**51 QUEENSWAY EAST,
SIMCOE ON N3Y 4M5**

Regarding: Response To Agency Comments Dated March 21, 2024

W:\Kitchener\423-2023\423025 51 Queensway East Simcoe\Design Phase\Correspondence\423025 County of Norfolk Response Letter - 2024-04-15.doc

Subject: **Response to Agency Comments**
Site Plan Application for 51 Queensway East, Simcoe

1 PUBLIC ENTRANCE & B.F. PARKING
1:100

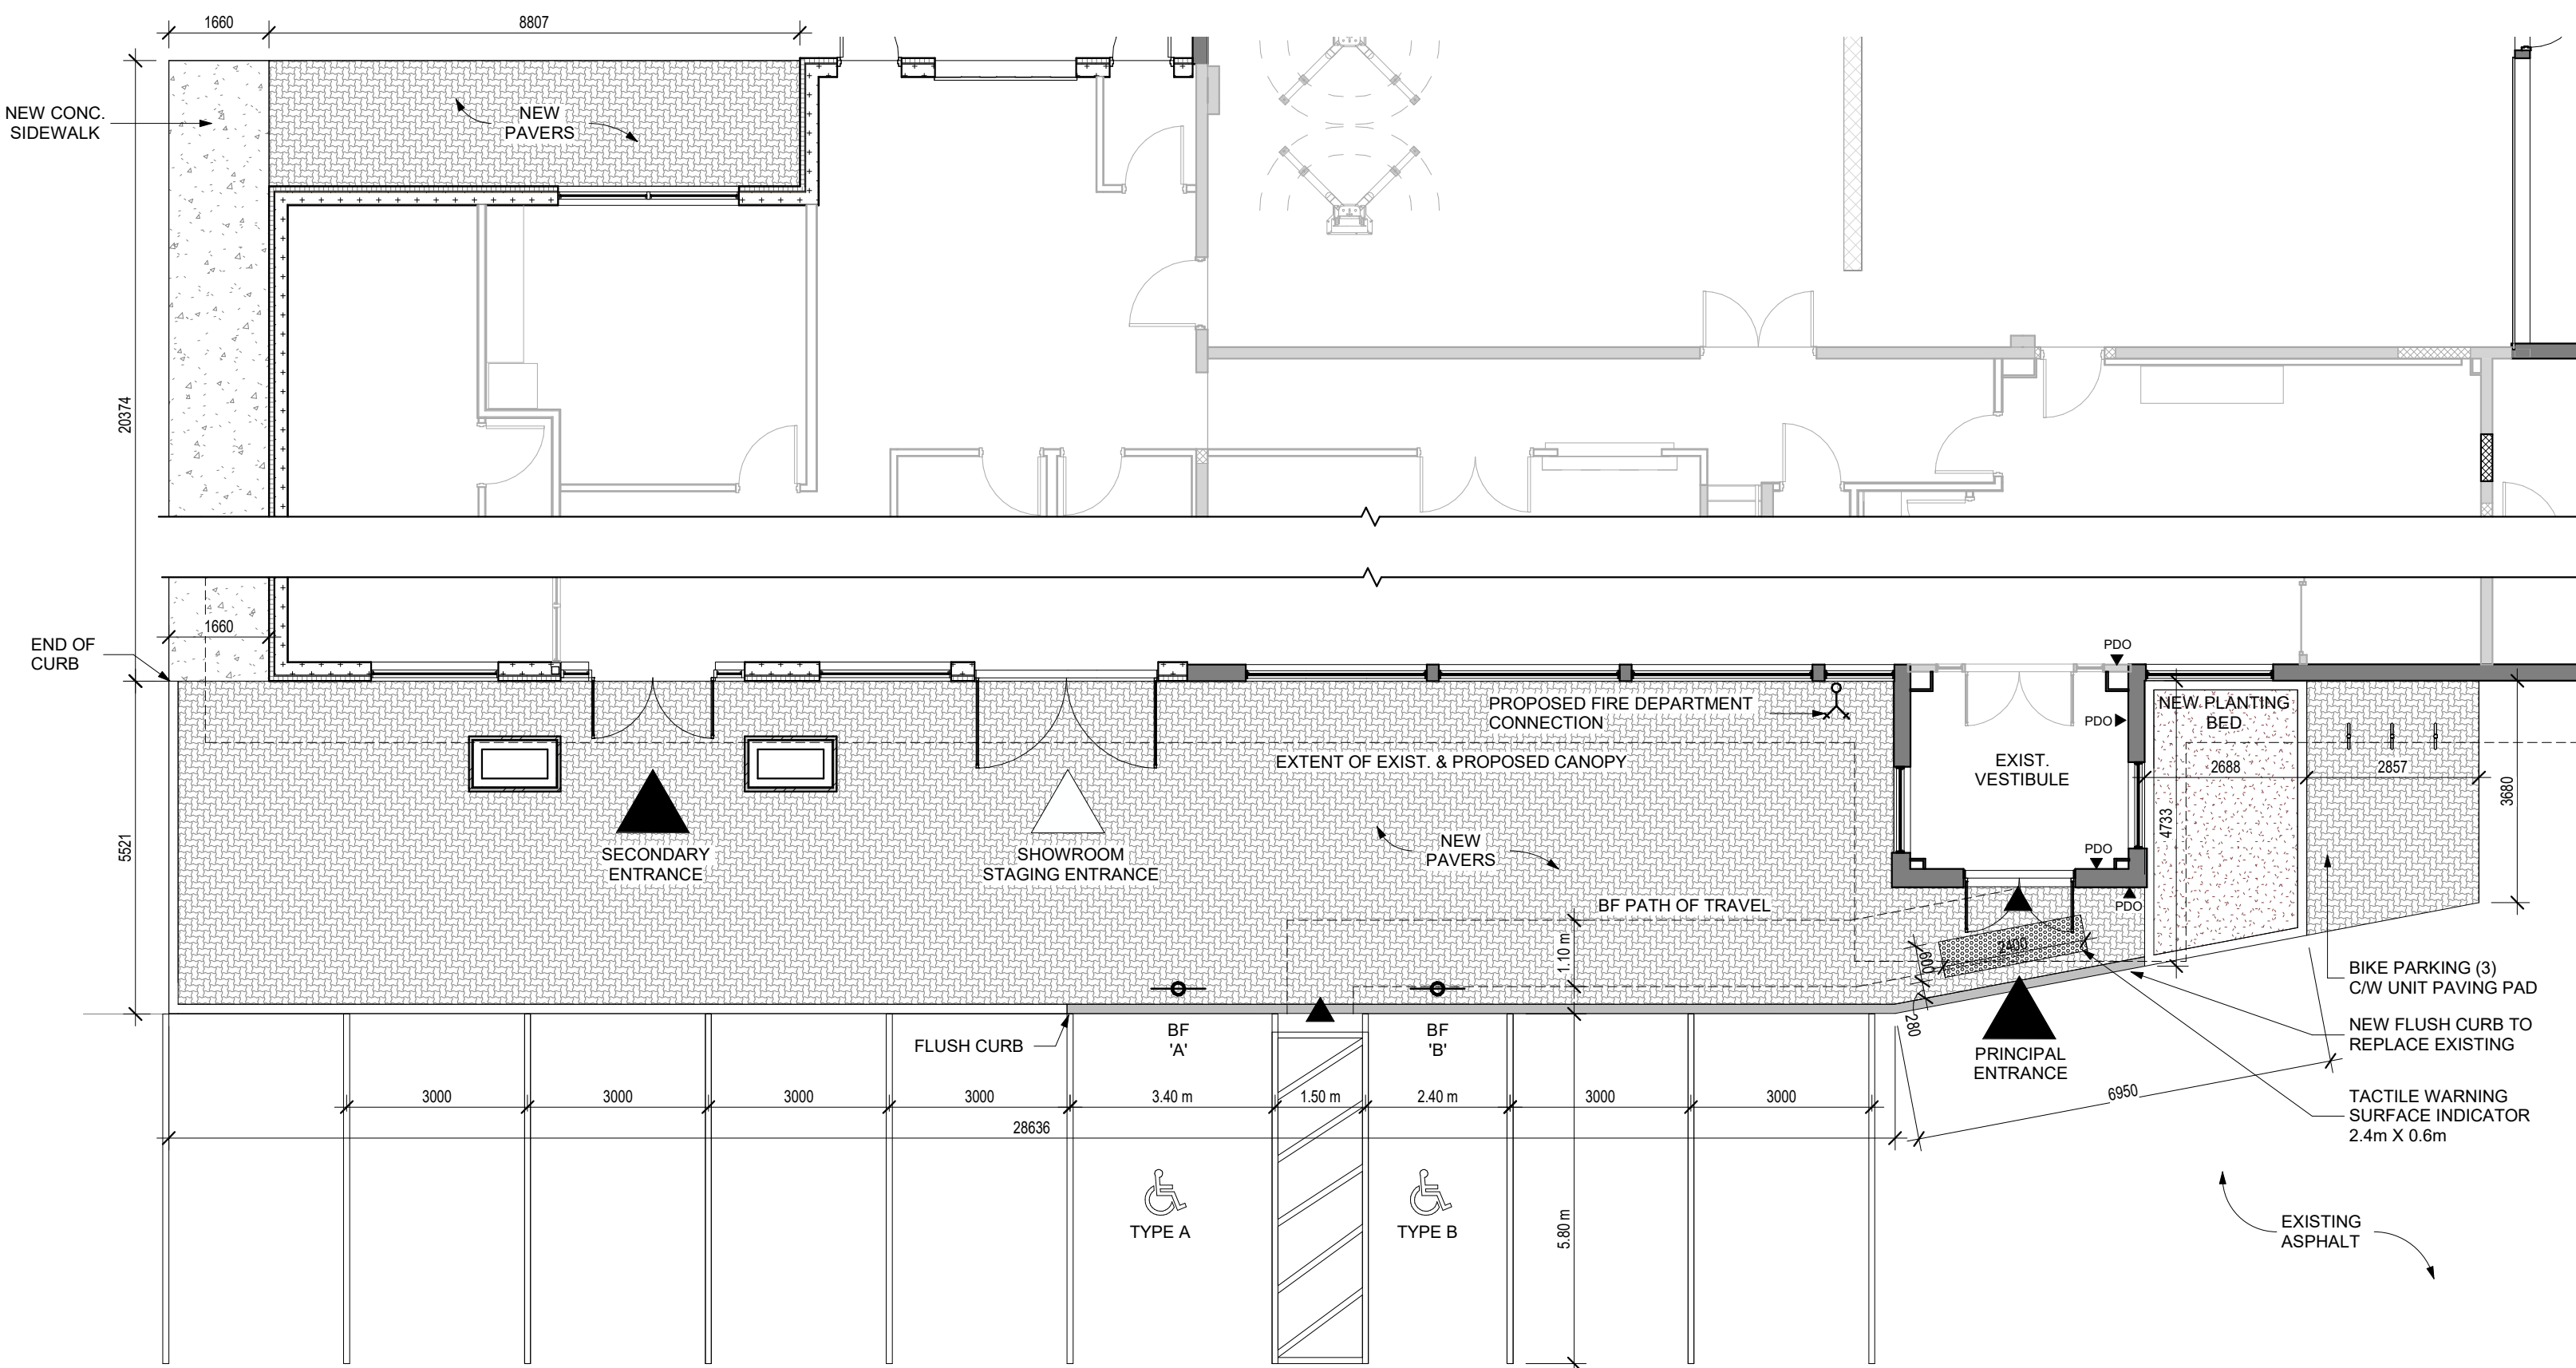
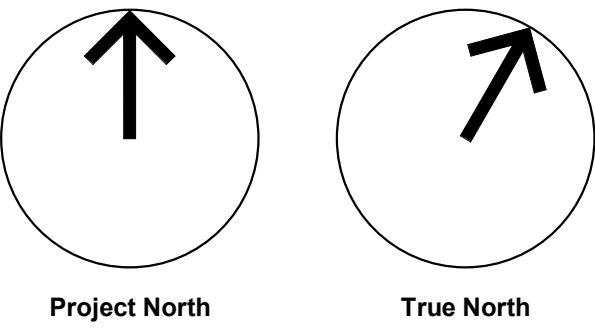
4. And further that indicate barrier free path of travel from parking area to building entrance to the satisfaction of the Building Department. Construction of curb cuts and location of tactile attention indicators is required. [OBC 3.8.1.3, & 3.8.3.2]
Provided, please refer to A1.2 Site Plan and 1/A1.3 Site Details.

ASPHALT PAVEMENT (LIGHT DUTY)

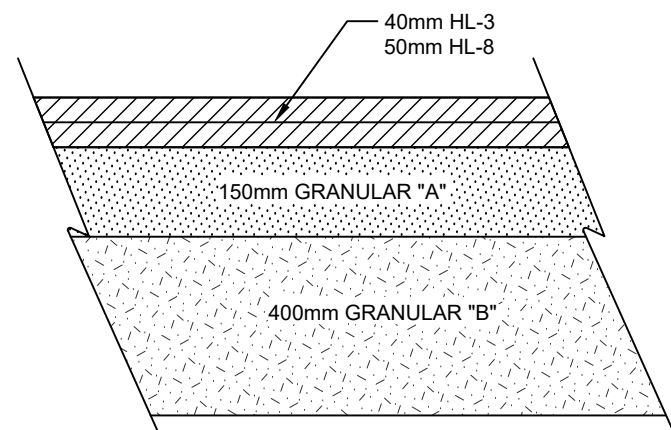
Comment 19: Provide asphalt detail and specifications referencing Norfolk County Design Criteria Section 6.7.01.

Response: *An asphalt detail has been provided on the revised engineering drawings.*

FIGURE: SP-1

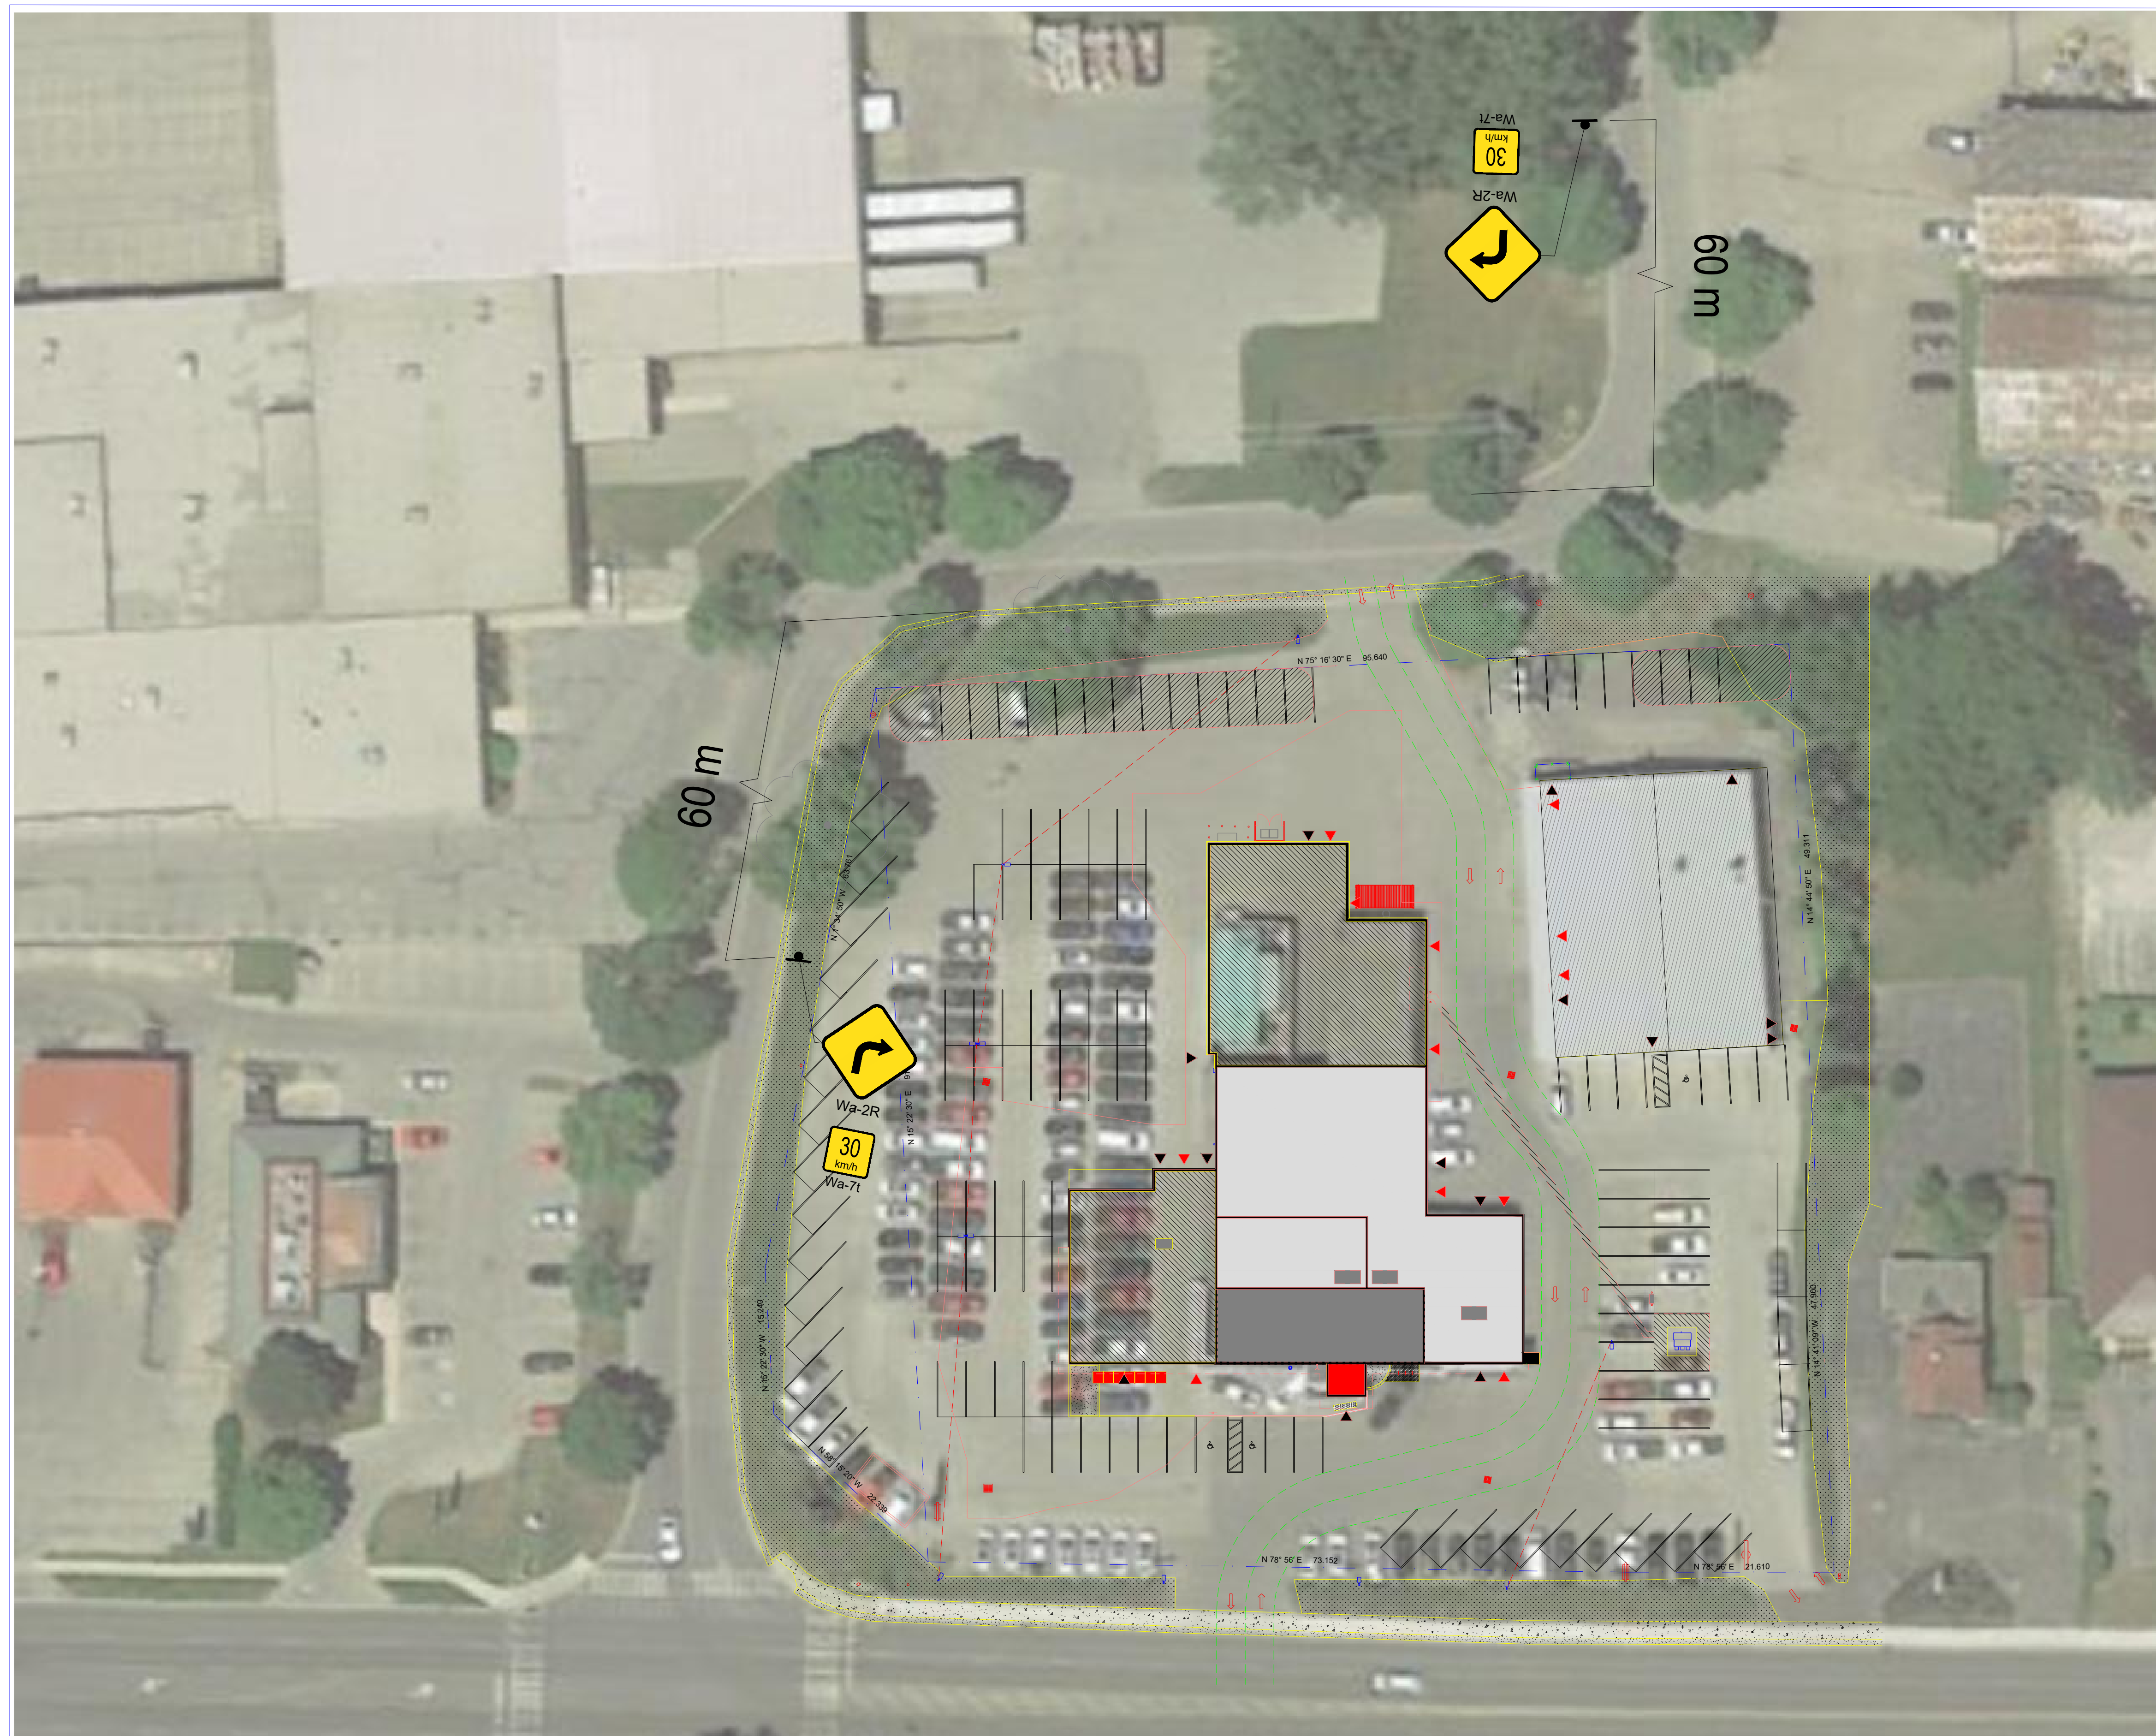
Please note the location of this signage on plans and include a detail for the future speed limit sign.

Signage was selected based on the Ministry of Transportation Ontario (MTO) *Ontario Traffic Manual, Book 6: Warning Signs*. A sharp right curve sign (Wa-2R) with a 30 km/hr Advisory Speed tab sign (Wa-7t) is proposed to be located 40 m in advance of the "S-curve" in both the northbound and southbound directions. A detail of signage from the *Ontario Traffic Manual, Book 6: Warning Signs* is provided in **Figure 1** and **Figure 2**. Note that these details are examples for each signage type, and the specific signage is shown in the functional signage plan in **Appendix A**.
